SUBJECT: COMANCHE PEAK NUCLEAR POWER PLANT, UNITS 3 AND 4
DOCKET NUMBERS 52-034 AND 52-035
SUPPLEMENTAL RESPONSE TO REQUEST FOR ADDITIONAL INFORMATION
NO. 4206 (SECTION 12.3-12.4)

SUPPLEMENTAL RESPONSE TO REQUEST FOR ADDITIONAL INFORMATION

RAI NO.: 4206 (CP RAI #135)

SRP SECTION: 12.03-12.04 - Radiation Protection Design Features

CP COL 12.3(10) **Figure 12.3-201 Yard Piping Routing and Building Penetration Schematic
(Not to scale)**

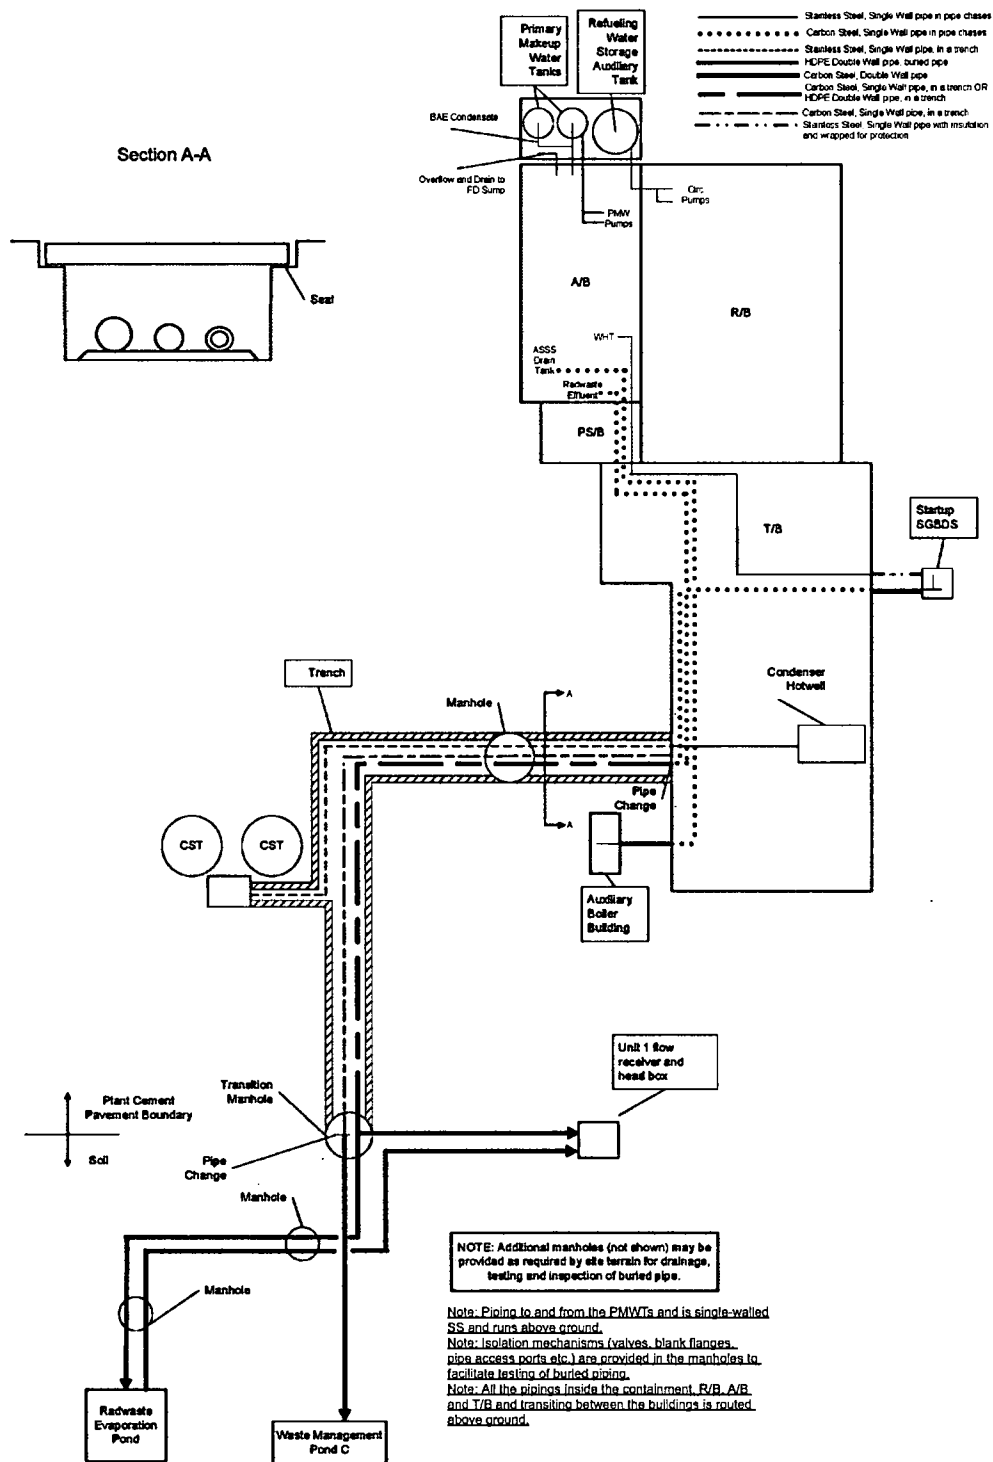
2. NRC Feedback: CPNPP Figure 12.3-201 shows the Auxiliary Boiler building, however, there is no discussion about the site-specific aspects of this building, or the site-provided piping and loads. Since this system can use the CST as a makeup water source, about the how potential contamination of loads is addressed. Also, since the Aux Boiler acts as a non-volatile contaminant concentrator, some discussion of the Aux Boiler blowdown lines may be warranted.

3. NRC Feedback: While the response discussed testing of buried piping in several locations, it is not clear from the response that the systems will contain the necessary isolation mechanism (valves, blank flanges, pipe access ports etc.) to allow hydrostatic or other non-destructive testing.

5. NRC Feedback: Section 2 of the RAI response indicates that there is no buried piping, and refers to above ground piping. Section 4 also refers to above ground piping. These points do not appear to be clearly indicated in either the DCD markup or Figure 12.3-201.

The effluent piping is divided into five segments as follows (refer to FSAR Figure 12.3-201):

The piping inside the Turbine Building, Power Source Building, Reactor Building, and Auxiliary Building, and transiting between these buildings, is routed in aboveground pipe chases because these buildings are close to each other. This information has been added to DCD Subsection 10.4.8.2.1 and to FSAR Figure 12.3-201.

See marked-up FSAR Revision 1 pages 9.2-17, 9.2-18, 10.4-8, 10.4-9, and 12.3-6 and revised Figure 12.3-201.

Figure 9.2.6-1 Condensate Storage Facilities System Flow Diagram

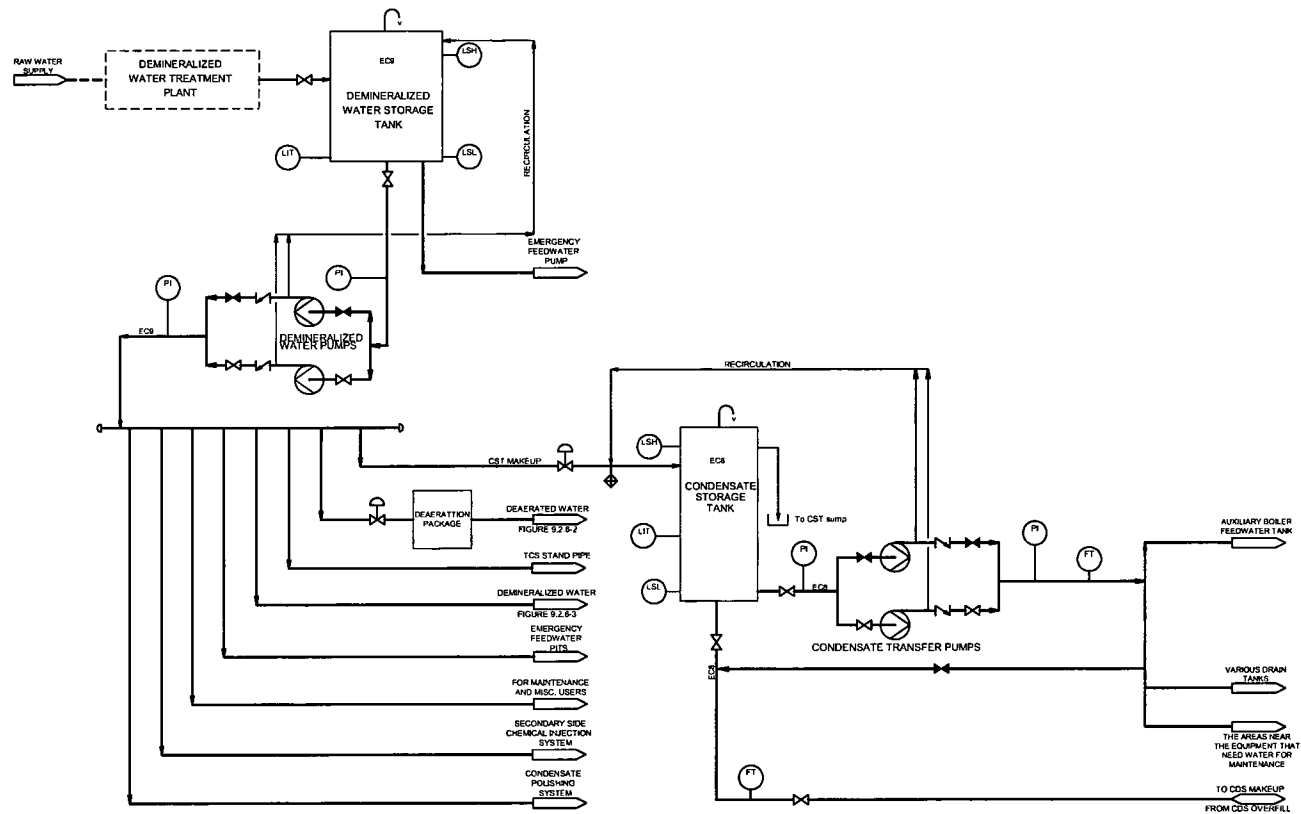
1. NRC Feedback: Drawing CPNPP 12.3-201 shows a line from the CST to the hotwell, however, there is no discussion of the CST overflow line depicted on DCD Figure 9.2.6-1 Condensate Storage Facilities System Flow Diagram. Since overflowing of the CST is fairly common, clarification of where this line runs would be useful.

The overflow from the CST is directed to the CST sump inside the dike area. The sump is equipped with an instrument to detect fluid level and initiate alarms in the MCR for operator action to stop condensate transfer and to investigate the extent of condition. After analysis for level of contamination, the contents inside the dike area can be trucked to the wastewater system (at CPNPP

Units 3 and 4, this is Waste Management Pond C) for disposal or to the LWMS for treatment and release.

FSAR Subsection 9.2.6.2.4 has been revised to include this site-specific information. DCD Subsection 9.2.6.2.4, Figure 9.2.6-1, and Table 12.3-8 Sht 15 have been revised to include the overflow piping to the CST sump.
